Artesian 230kV Substation Expansion Project CPUC Minor Project Refinement Form

Date Requested: March 10, 2021

Report No.: MPR

Photo 1. Overview of the MPR temporary pole location, within the existing work area for NTP-approved Locations 2 (R05), 3 (R03), and 4 (P03). The NTP-approved work area for these locations covers the entire area shown, and extends beyond the view of this photograph. View southeast.

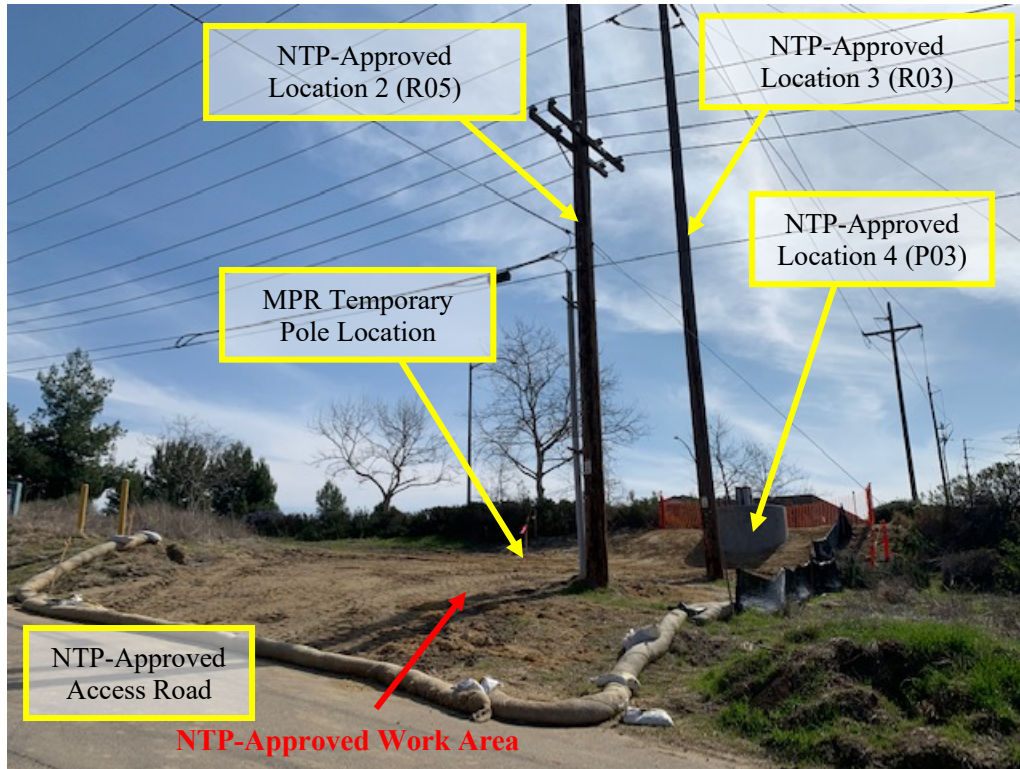
This minor project refinement (MPR) includes installation of a temporary steel pole within the existing, NTP-approved work area of these locations (See photos in Attachment A and Figure 1 in Attachment B).

The work area required for the installation of the MPR temporary pole is 314 sq. ft. within the NTP-approved work area, approximately 22 feet east of the existing poles. Access will be via the NTP-approved access road and overland travel through the existing, NTP-approved work area (See Figure 1 in Attachment B). Therefore, no additional work area is required for this MPR.
